Vermont Agency of Transportation
RECEIVED
CK'D BY NDVB OK'D BY SSS
RESUBMIT BY
APPROVED AS NOTED
DATE 11/15/2011

VERMONT AGENCY OF TRANSPORTATION
PROJECT NAME: BETHEL
PROJECT NUMBER: BRF-022-1(14)

TRANSVERSAL EXPANSION HLMR POT BEARING

FOR: BECK & BELLUCCI	SHEET NO 5 of 7	DWG NO: BB11A5RC

SPAN PIER TRANSVERSE GUIDED BEARING (N3)
QTY. REQ'D = 1
924 KIPS

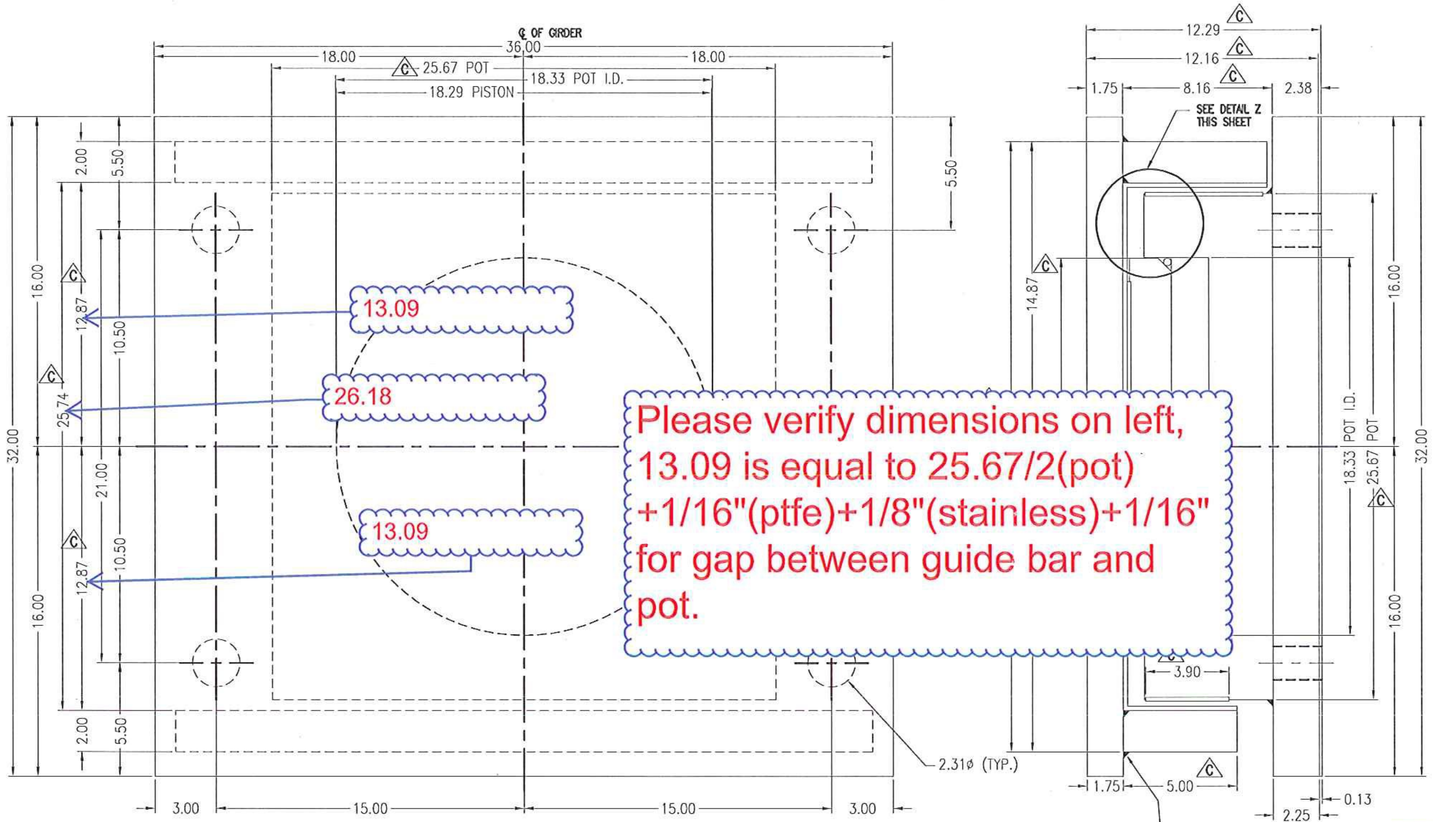
Please verify dimensions on left, 13.09 is equal to 25.67/2(pot) +1/16"(ptfe)+1/8"(stainless)+1/16" for gap between guide bar and pot.

1/2, ON SHEET 4 OF DESIGN CALCS IS SAYS FOR A FILLET WELD TO USE 1/2"

DETAIL Z

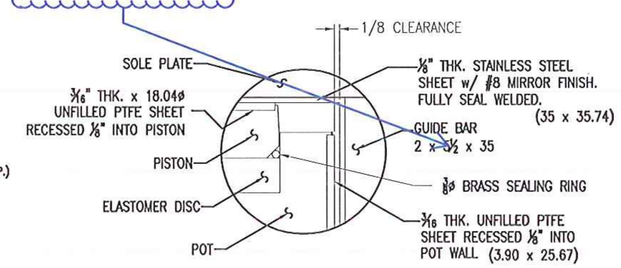
The corrected version is the sheet before this one
